PRODUCT UPDATE

#208

New T Series Collet Nut

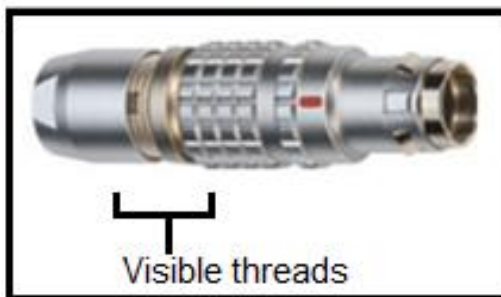
The form of the collet nuts used on the T Series cable mounted plugs and receptacles have changed. Fit, form and function of the connector remains the same. Existing inventory is not affected by this new collet nut.

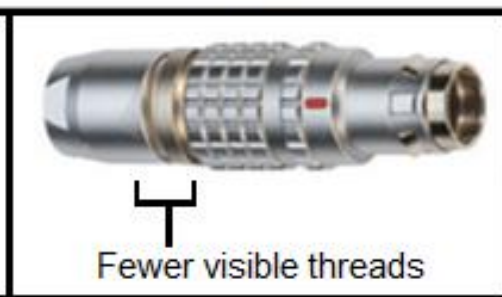
The 0T, 1T and 2T sizes previously used the B Series collet nuts and will now be supplied with a new T Series collet nut which is slightly longer. Fewer threads will be visible (as shown in the diagram below), and the longer collet nut will cover the anti-rotation slot, while the overall length of the connector will remain unchanged. This affects both standard and bend relief type collet nuts.
